RETAINING WALL CONSTRUCTION RECORD

Hillcrest Shores, phase 3, Rockwall, Texas

RE: SURCHARGE RETAINING WALL SCHEDULE

RE: REVISED PARK VIEW DRIVE RETAINING WALL SCHEDULE

JORDAN CONSULTING ENGINEERS 2400 HOORINGY 207 HOWEN, SUFER TOS MAINTENER, TRANSPORTOR 817-453-46070							
REVIS HILLC	OION, PIE REST SH	RS #33,3: HORES, 3	5,37,39 ROCKWALL	,41 -,7X			
DRAWN BY	SOME	DATE	PROJ. NO.	SHEET NO

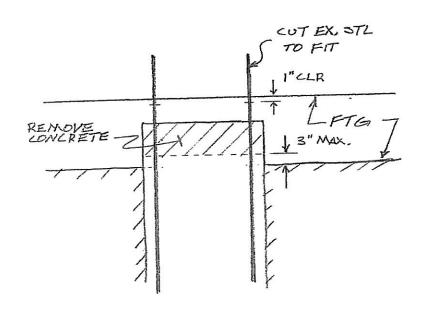
Revisions were made to the structural wall at Block 'B', Lots 3 through 7, as follows: 1) A new detail was provided for footing dowels and the stone walls were built atop the footings in accordance with the original gravity wall schedule. 2) Errors were discovered in the field survey on Lot 5 after pier installation. The staked bottom of wall elevations did not align properly. The wall elevations were revised to fit and two new details were provided.
